FINAL DRAINAGE PLAN AND REPORT

16140 OLD DENVER ROAD

PCD File No. PPR-16-037

SUBJECT: Drainage Plan and Report
All About Outdoor Storage PPR-16-037

Detention Basin Outlet Structure Design

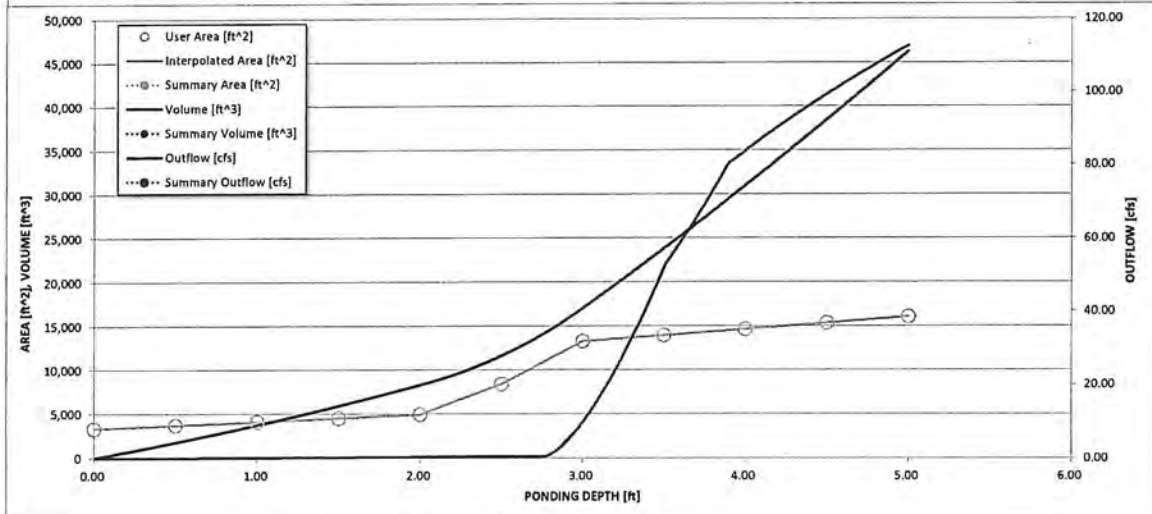
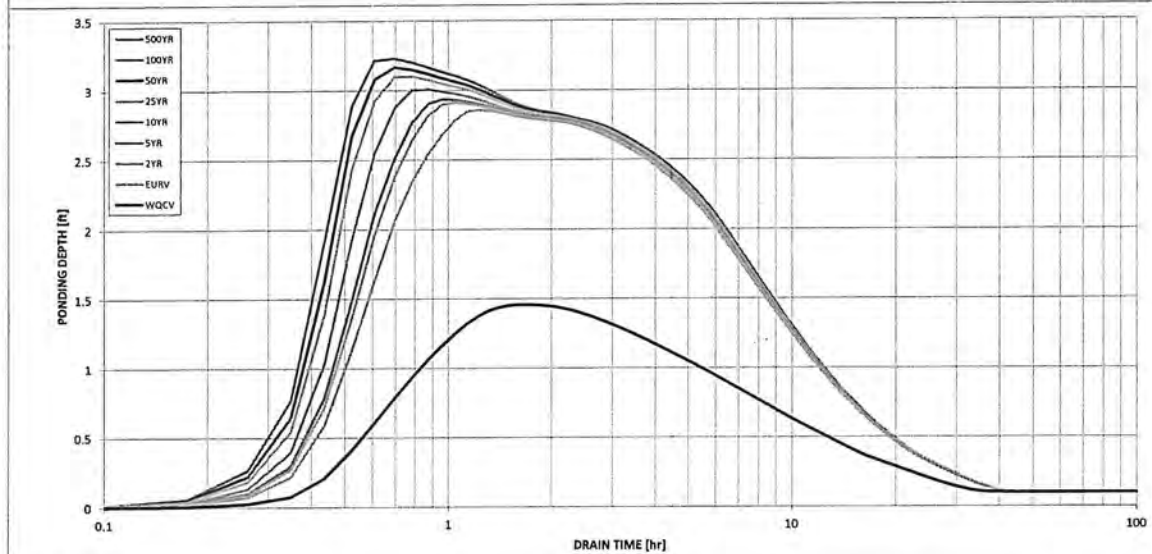
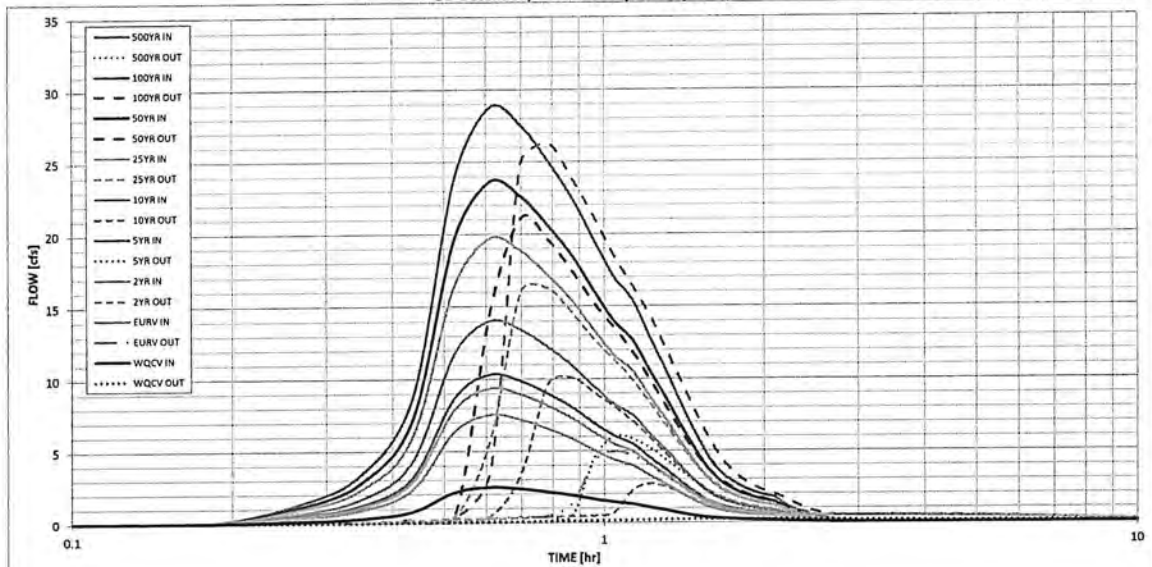
Consider revising to provide a maximum of 3 rows of orifice holes per MHFD recommendation.

Revise design to meet release time criteria for the WQCV

Revise design to release at or below predevelopment Q

Figure 13-12d. Riprap Types for Emergency Spillway Protection

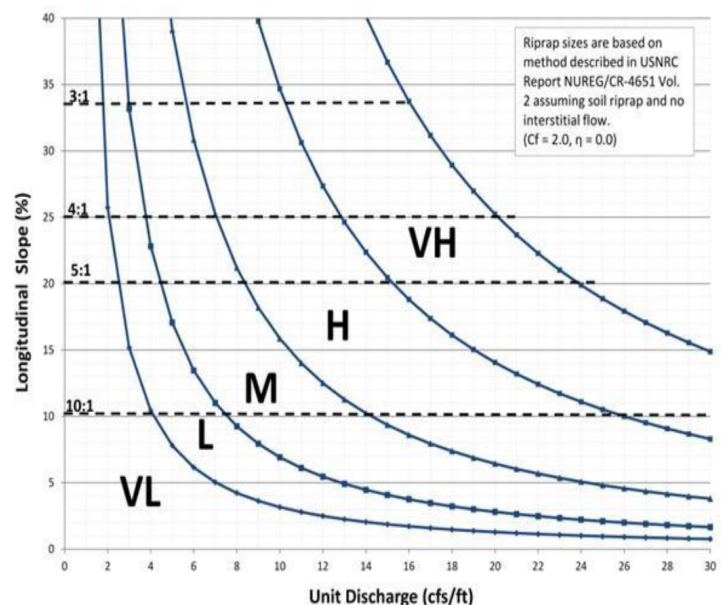
Provide the erosion protection calculation for the spillway. See table to the right taken from the City DCM for spillway protection. Include in the resubmittal
